car stereo Service Bulletin No. 92

Model: XR-50/70

Date: December 28, 1987

Subject: Tape Deck Mechanism Parts
Change - Reference No. 385,
387, 388

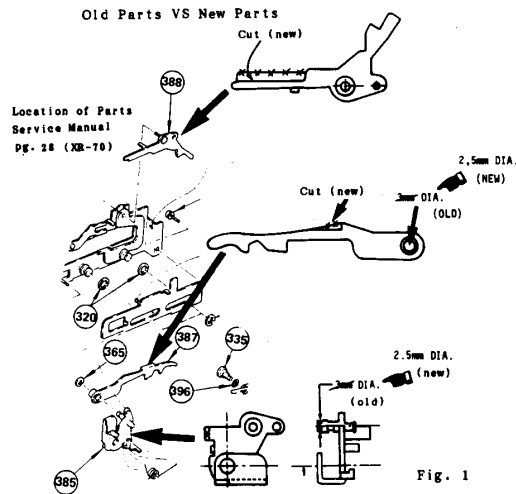
During the production of the XR-50/70 car stereo, a change was made in the tape deck mechanism. The parts which are affected are shown below. The specific portion of the part that was changed is also shown (Fig. 1).

The new parts and old parts are not compatible with one another. Only the new parts are available from Kansas City Parts. If any one of these three parts must be changed in a unit containing the old parts, all three parts must be changed. The part numbers for the three parts have not been changed from the originals.
